ADDENDUM NO. 1

DATE: January 27, 2016

SUBJECT: **Seguin Animal Shelter**

- **Revised Sheets C103; C106, IRR-1; ES-101; E-101; E-401**
- **Specification Section 32 31 13 – Chain Link Fence**
- **Revised CIQ form and form 1295**
- **Prebid sign in sheet**

C-103

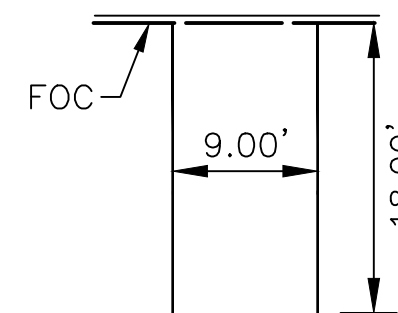
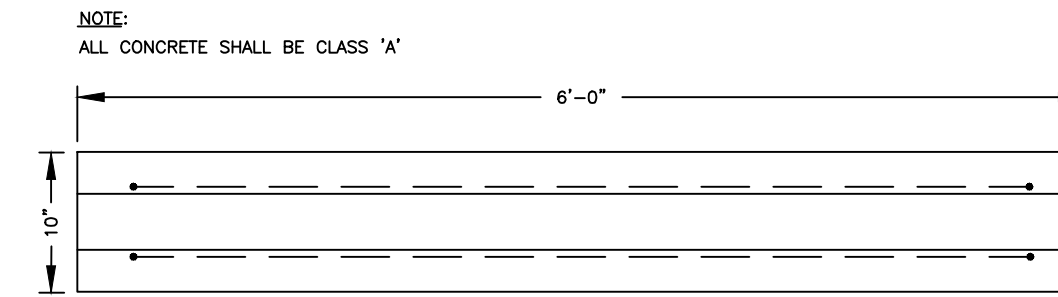
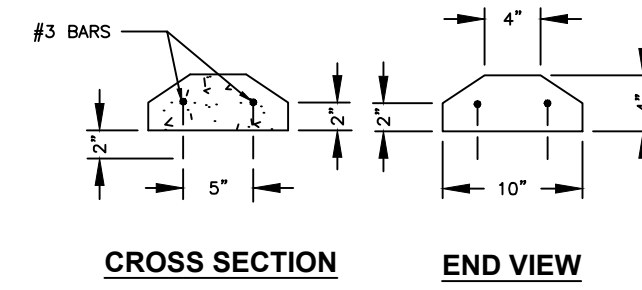
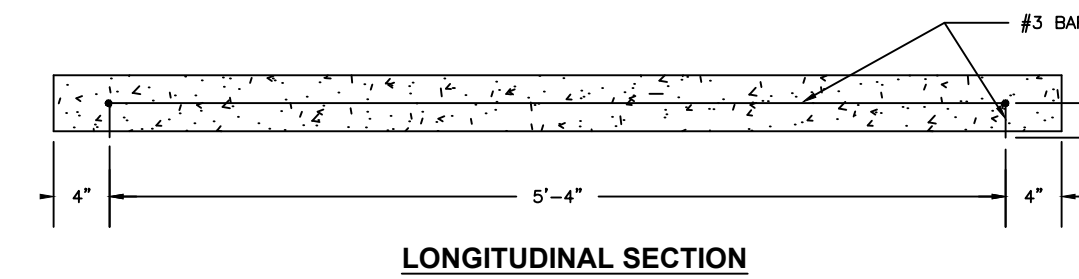
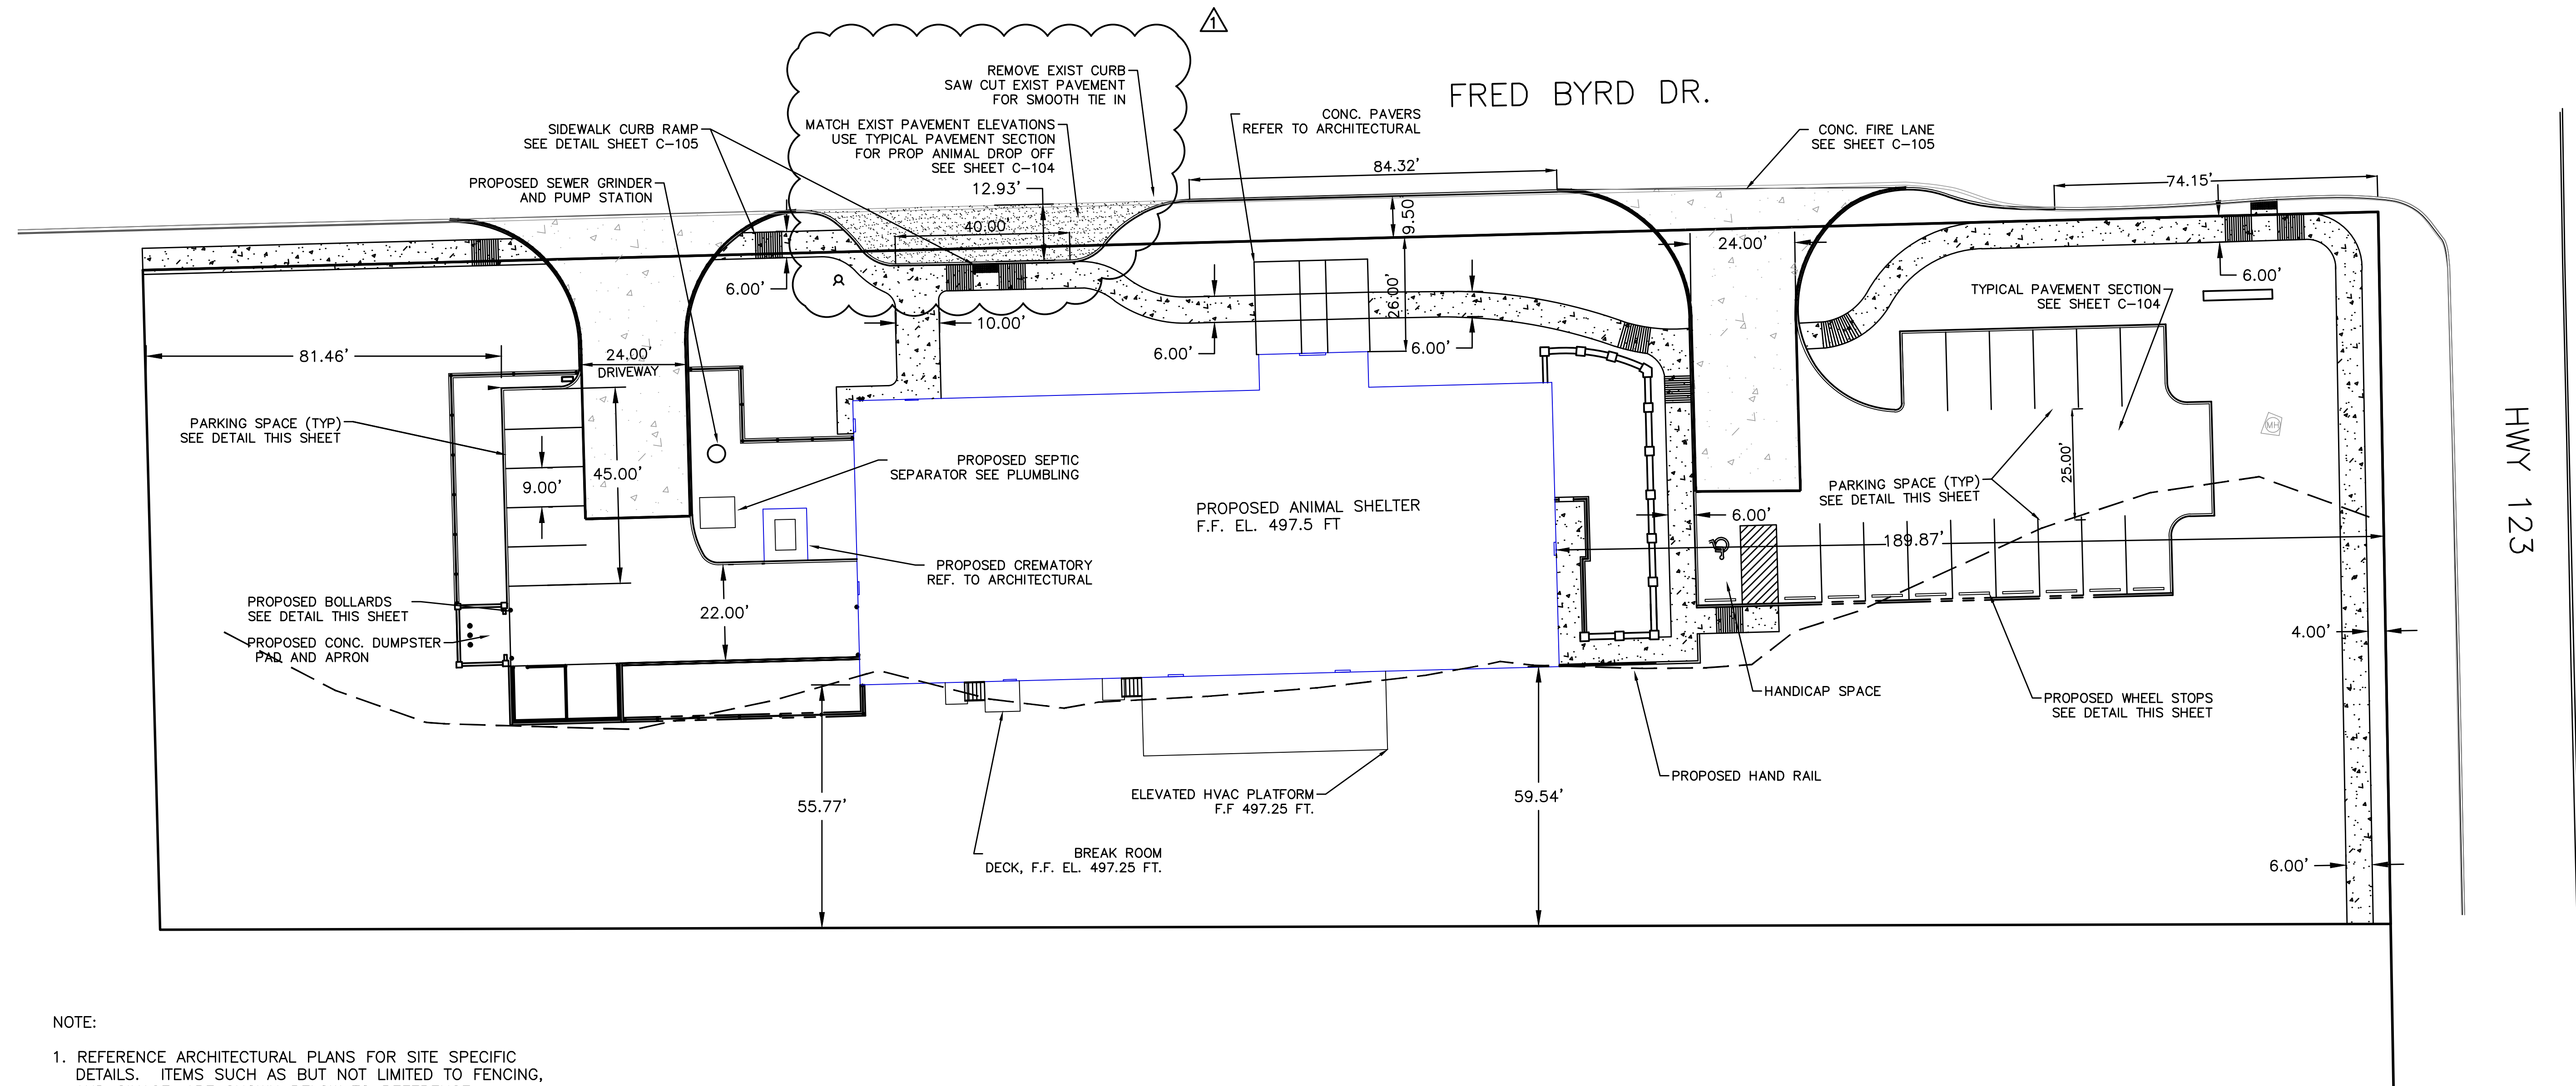
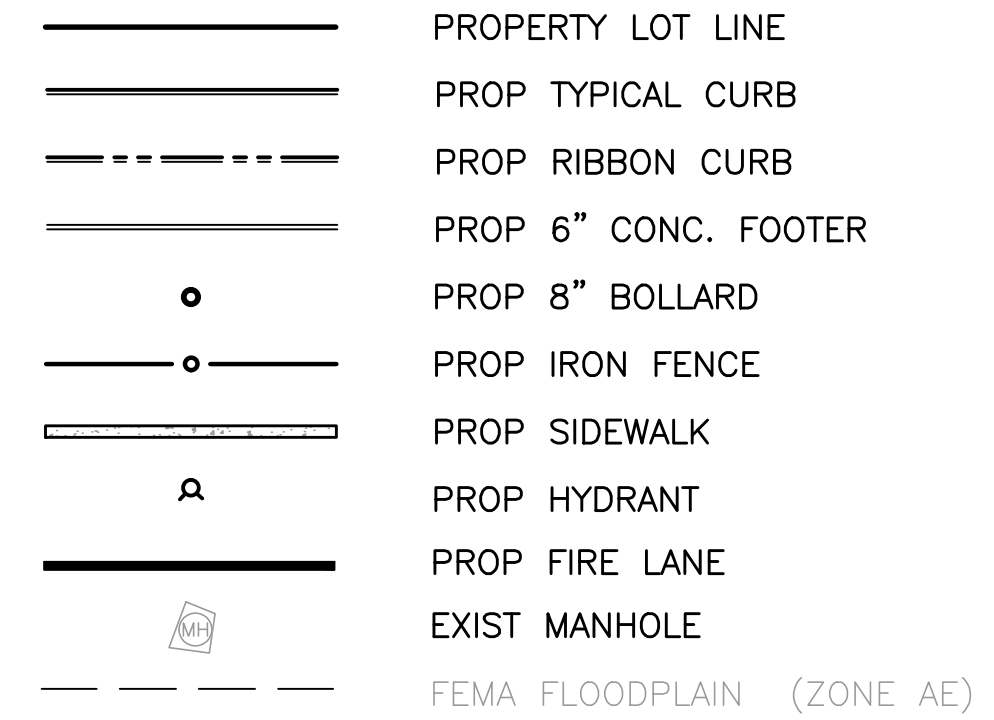
33. At new Drop-Off lane along Fred Byrd, sawcut and remove existing curb. Construct new Drop-Off are as indicated in accordance with revised C103 and City of Seguin Standard Street Details, including concrete curb.

1. ADDED DETAIL AND CLARIFICATION FOR THE ANIMAL DROP OFF

C-106

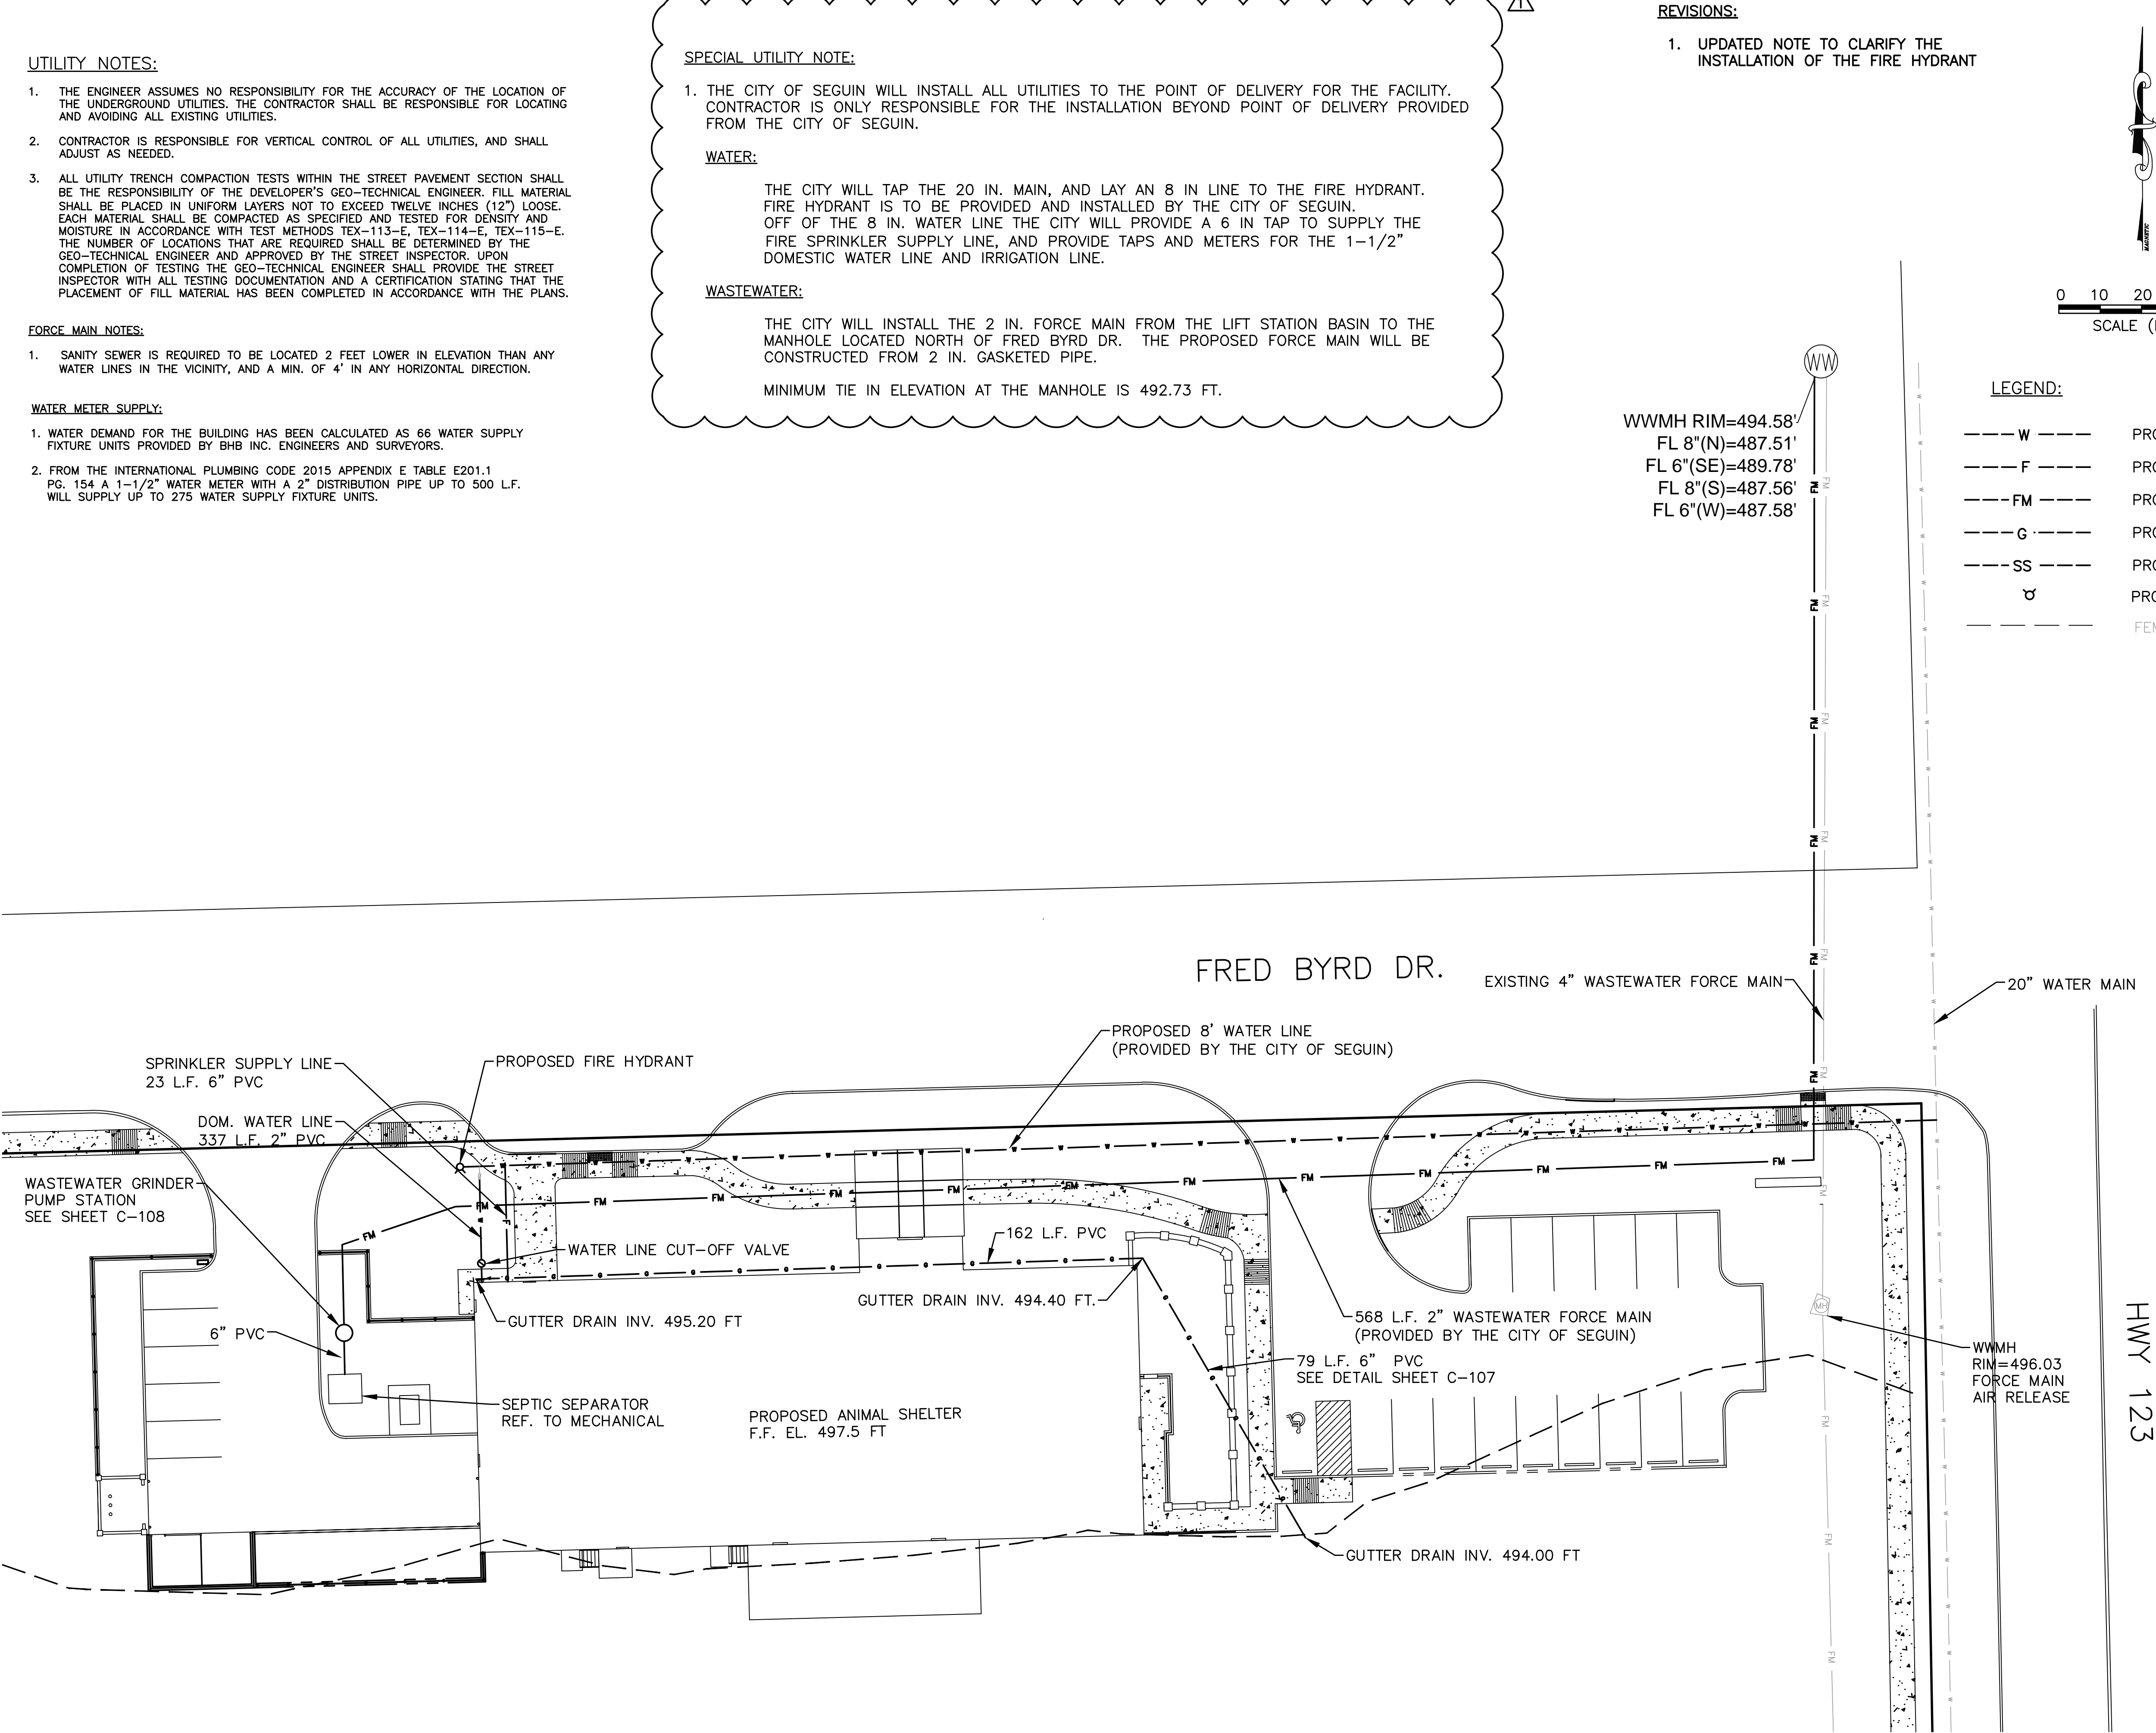
8. Note that the City is providing site utility services to the building as described on sheet C-106 on the drawing and under special utility note to save money. This includes the proposed FH indicated on the drawing on C-106 as well as meters and vaults. Under the Base bid contract, the Contractor will install service from and including the lift station and grinder pump to and throughout the building.

1. UPDATED NOTE TO CLARIFY THE INSTALLATION OF THE FIRE HYDRANT

THE CITY WILL TAP THE 20 IN. MAIN, AND LAY AN 8 IN LINE TO THE FIRE HYDRANT. FIRE HYDRANT IS TO BE PROVIDED AND INSTALLED BY THE CITY OF SEGUIN. OFF OF THE 8 IN. WATER LINE THE CITY WILL PROVIDE A 6 IN TAP TO SUPPLY THE FIRE SPRINKLER SUPPLY LINE, AND PROVIDE TAPS AND METERS FOR THE 1-1/2" DOMESTIC WATER LINE AND IRRIGATION LINE.

IR-1

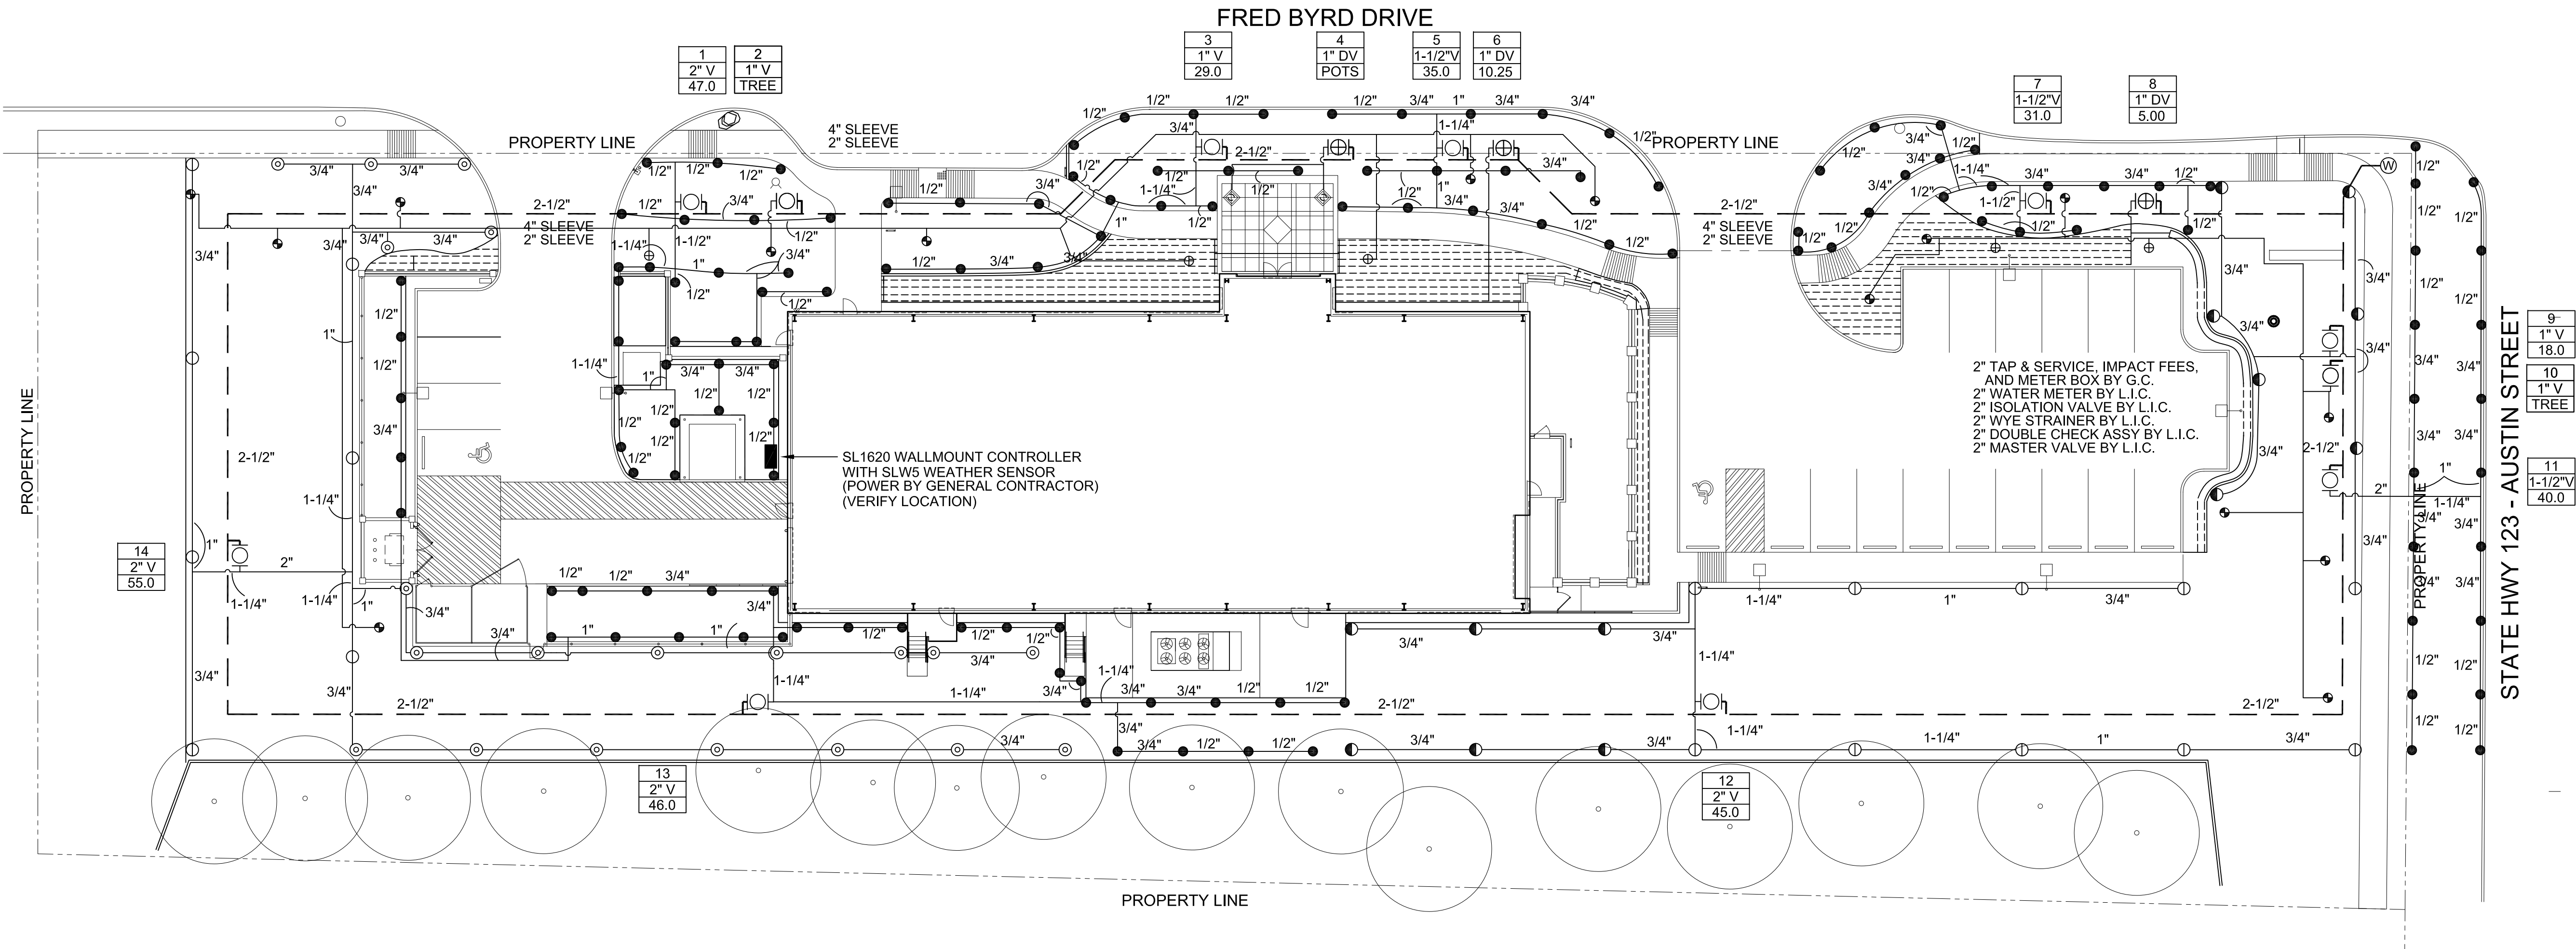
9. Refer to Note 42, AS-101 The relocated street lights will be the responsibility of the Owner.
10. Refer to Sheet IRR-1 note the valve information in State Hwy 123 was cut off on the original printing. See attached, sheet with this information for valves 9, 10 and 11.
